## MKS TECHNICAL BULLETIN:

### Specification change of BM-7 copper plated plate

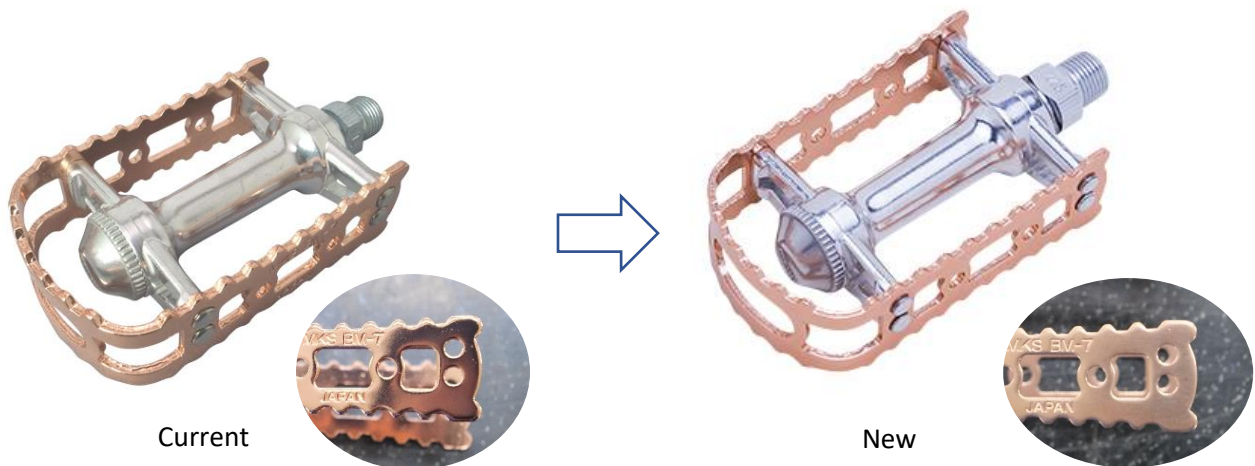
- The surface treatment of the aluminum side plates used for BM-7 Copper will be changed.
- The conventional copper plating and clear coat treatment will be replaced by copper-colored anodization (right photo). The conventional glossy look is gone, and the color is more subdued.
- Anodization, also known as anodic oxidation treatment, is a surface treatment in which an oxide film is generated on the surface of aluminum by electrolytic treatment with an anode. It contributes to corrosion and wear resistance.
- As soon as the stock of the old specification runs out, the changeover will be applied as a running change. Each supplier will be notified individually at the time of shipment when the changeover will be applied.
